**CITY COUNCIL
REGULAR MEETING STAFF REPORT
AGENDA ITEM 7B**

TOPIC: Erickson Property

i. Consider 1st Reading of Ordinance No. 13-25 Rezoning
Property from R, Rural to R-2, Two Family Residential

ii. Consider Resolution No. 25-93 Approving Preliminary Plat

**SANITARY SEWER, WATER & STORM
SEWER PLAN**

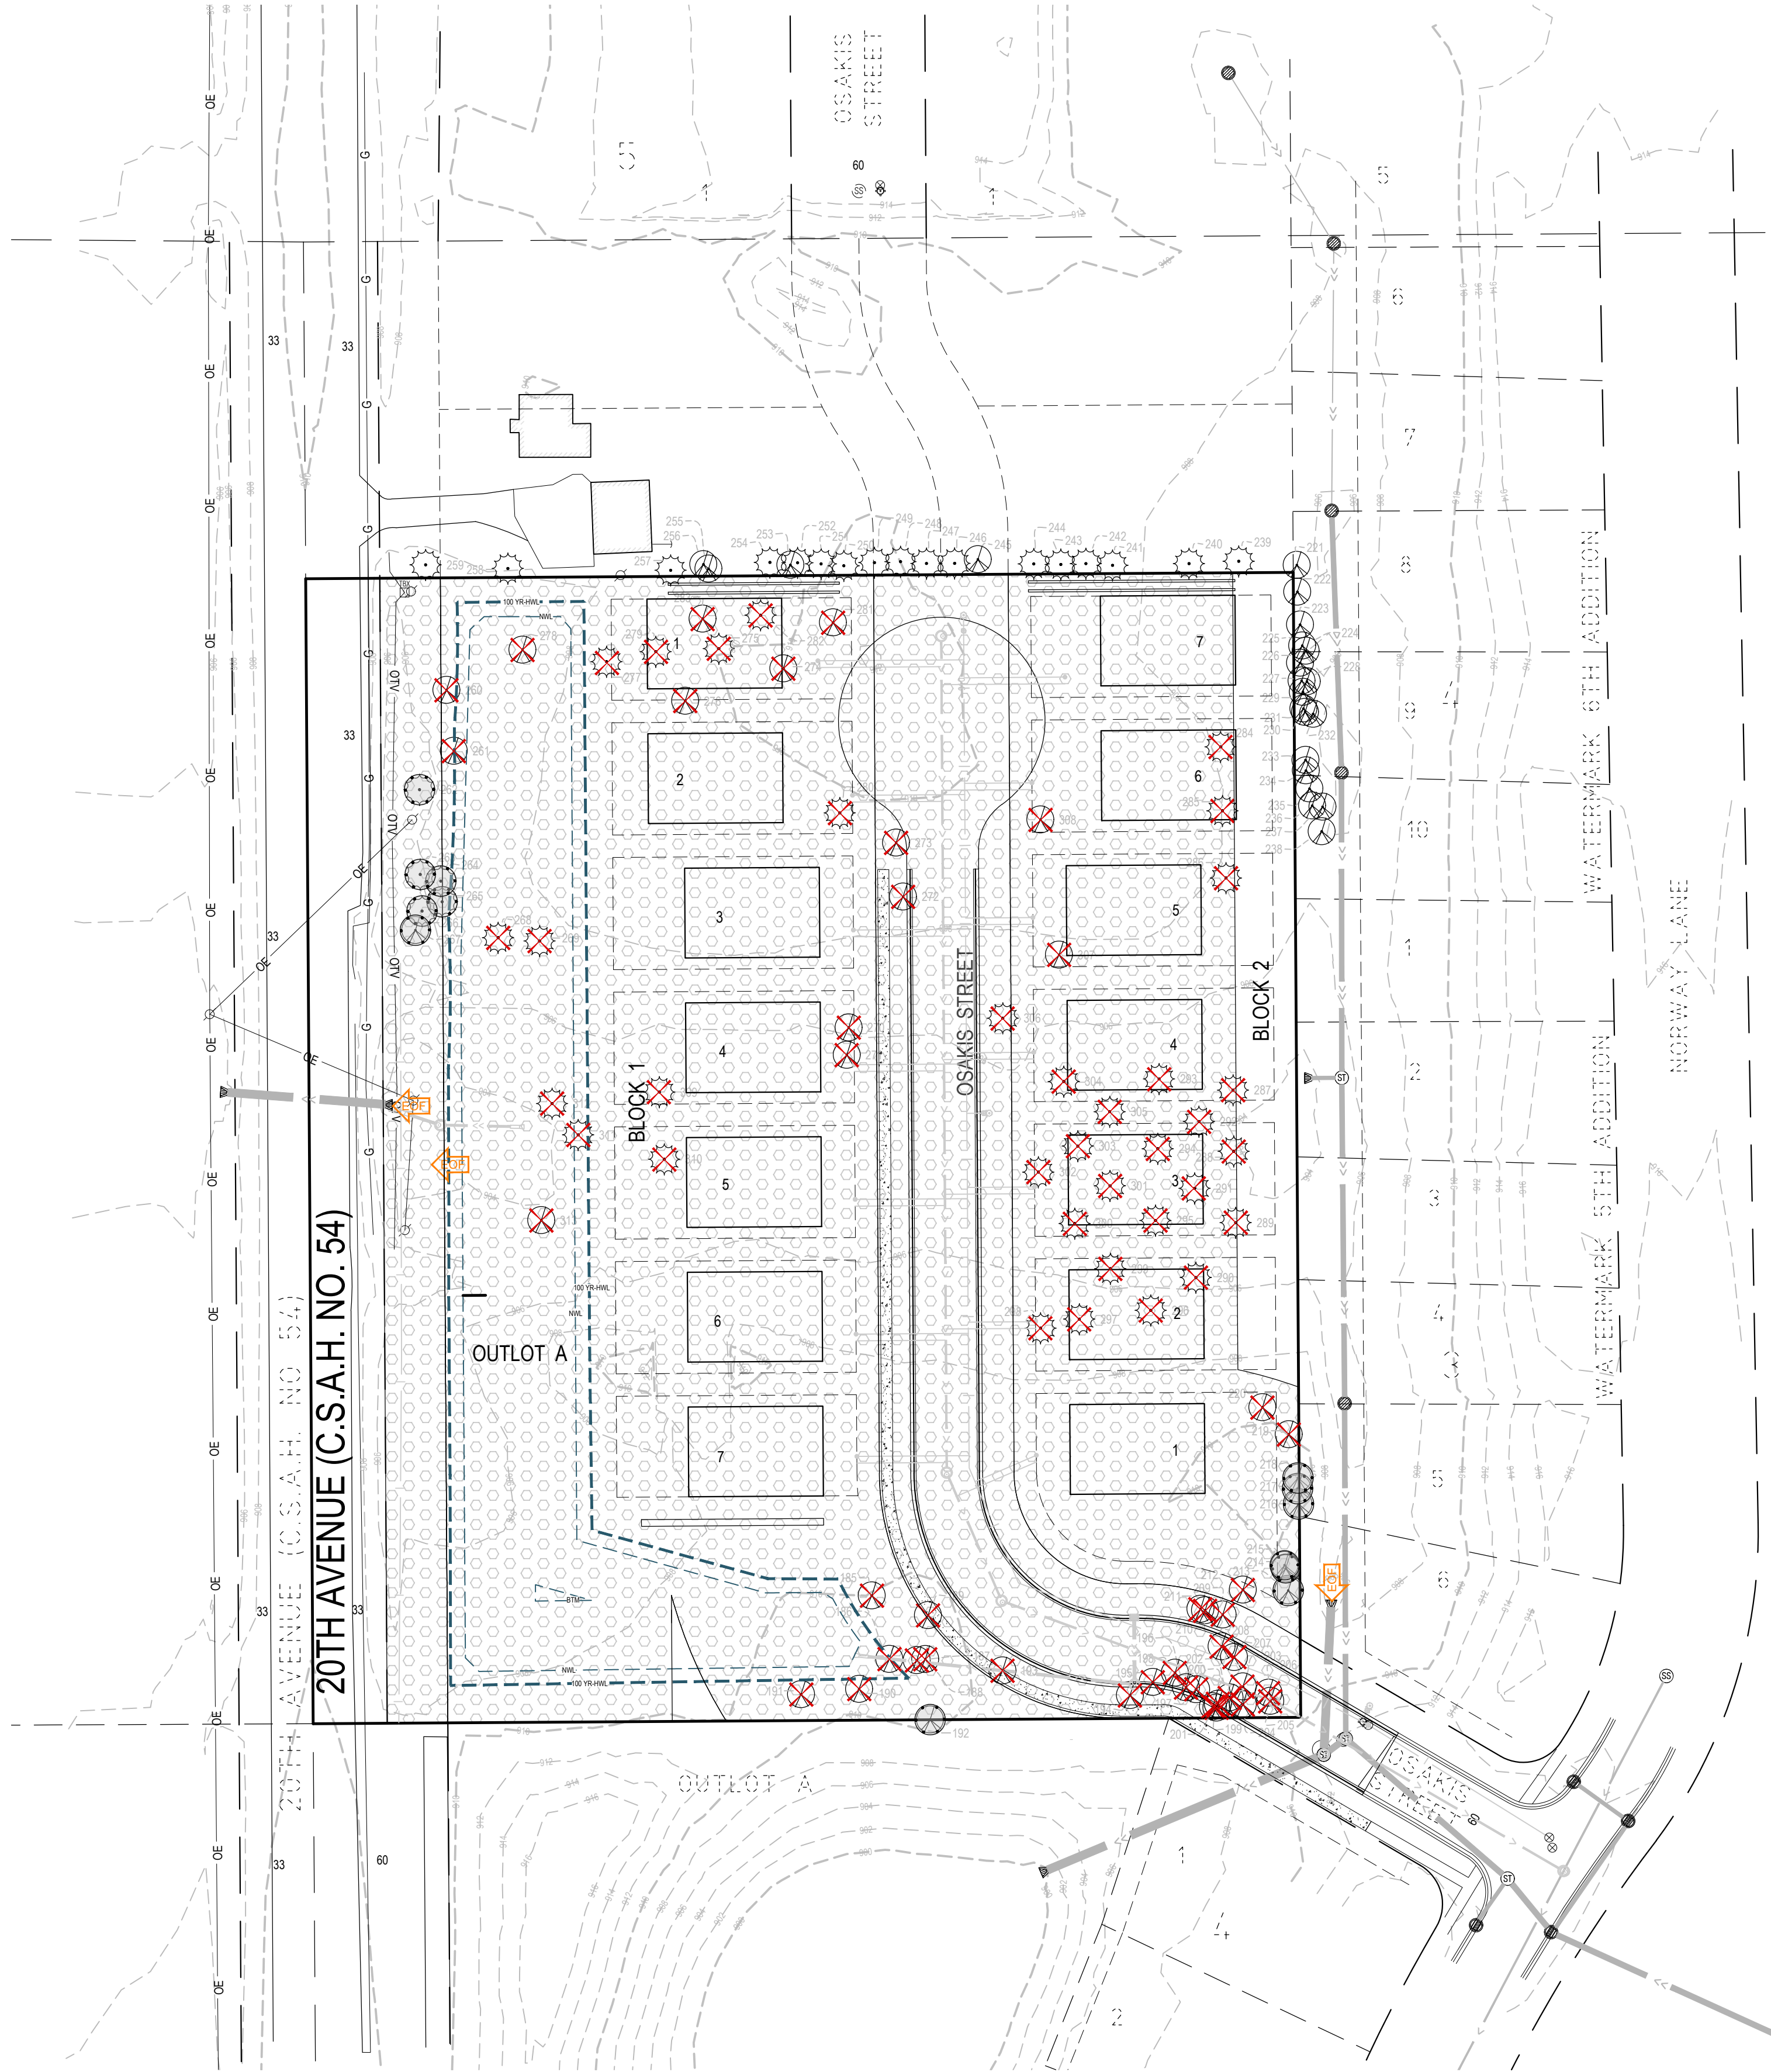
1. Provide utility profiles
2. Call out all utility crossings
 - a. Maintain minimum 18" separation
 - b. Insulate when separation between water (services/main) and storm sewer is less than 36"
3. Show existing watermain along Norway Ln
4. Test the existing gate valve in Norway Ln
 - a. If holding, utilize the existing gate valve in Norway Ln for testing
 - i. Do not connect to existing with a gate valve
 - b. Otherwise, remove watermain back to and including existing gate valve
 - i. Connect to existing with new 8" gate valve at that location
5. Utilize current utility as-builts/plans for Watermark 5th and 6th Additions

1. Provide utility profiles
2. Create a detail for connection to existing sanitary sewer main with sanitary manhole
 - a. Describe process for maintaining existing sanitary sewer, watermain, and storm sewer service as well as vehicle access during construction

- b. Review impact of proposed sanitary sewer main on existing storm sewer and watermain
 - i. Provide how existing utilities will be protected during installation or salvaged and reinstalled or removed and replaced
 - ii. Possible redesign/realignment of storm sewer
 3. The sanitary sewer segment between MH-117 and MH-116 should be 8" PVC SDR 26
 - a. All other sanitary sewer main should be 8" PVC SDR 35
 - b. The minimum required slope is 0.40%
 4. Update all details C7.X/X shown on the plans
 5. Install 8" future sanitary sewer plug to the north of MH-113
